HYUNDAI Technical Service Bulletin

Group	CLIMATE CONTROL
Number	07-97-001
Date	APRIL, 2007
Model	2007 ENTOURAGE

Subject
2007 ENTOURAGE A/C COMPRESSOR DISC AND HUB REPLACEMENT

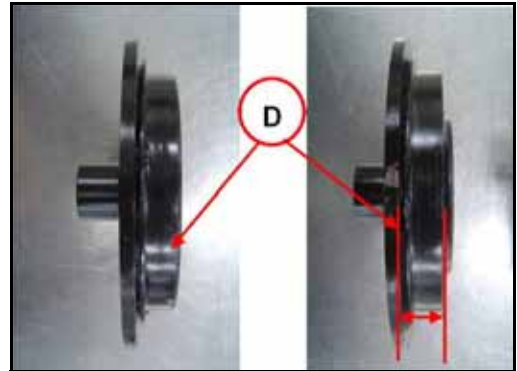
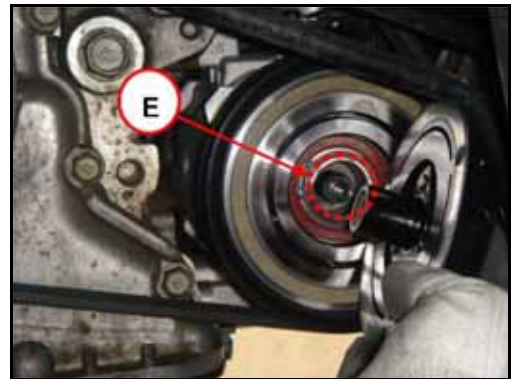
NOTE: Rubber thickness on new part has been increased.

6. Install new disc & hub assembly (D).

7. Install clearance shim before installing the disc & hub assembly (E).
